UNITED STATES PATENT AND TRADEMARK OFFICE

APPLICATION NO.	FILING DATE	FIRST NAMED INVENTOR	ATTORNEY DOCKET NO.	CONFIRMATION NO.
10/566,698	05/30/2006	Jens Brandt	S4-03P09159	9692

Office Action Summary	Application No. 10/566,698	Applicant(s) BRANDT ET AL.	
	Examiner ANATOLY VORTMAN	Art Unit 2835

DETAILED ACTION

FIG. 5

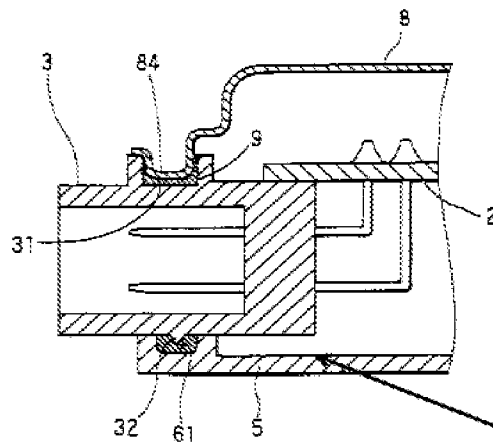
5. Applicant's arguments have been fully considered but they are not persuasive. The gist of the Applicant's arguments is that, allegedly, "Kobayashi et al. however, do not teach a housing floor having an indentation, but rather teach a flat housing floor as can be seen in Fig. 1".

Contrary to the Applicant's position, Examiner would like to direct the Applicant's attention to the annotated Fig. 5 and 6 below, which clearly show the indentation in the floor (5):

The housing floor is the entire element (5), including the protruding internal lateral sections (52, 53). Therefore, the low laying surface area surrounded by said protruding lateral sections (52, 53) is the “indentation” in said floor.

FIG. 6

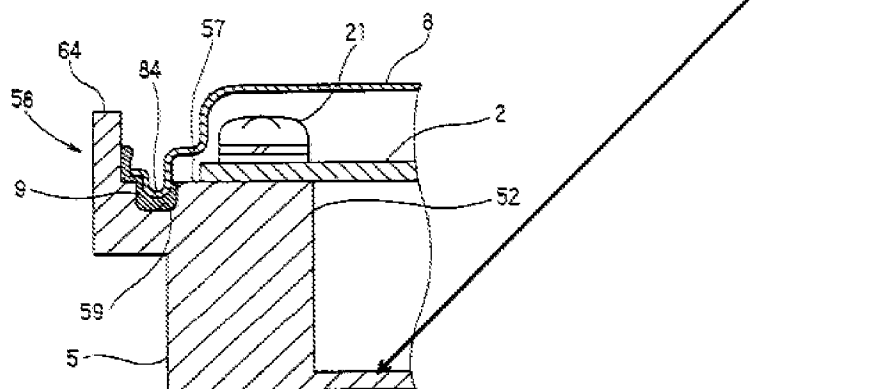
Furthermore, Applicant contends that “Murowaki et al. do not teach housing internal sections that dissipate heat away from the printed circuit board and that serve as the main support for the printed circuit board”. This argument is irrelevant. The Murowaki et al reference has been used only because of the teachings of the heat conductive adhesive. It is the primary reference (US/2002/0112870 to Kobayashi et al) teaches the internal lateral sections (52, 53), which dissipate heat (inherently) from the printed circuit board (2) and serve as the main support for said circuit board (2) (see Fig. 6).
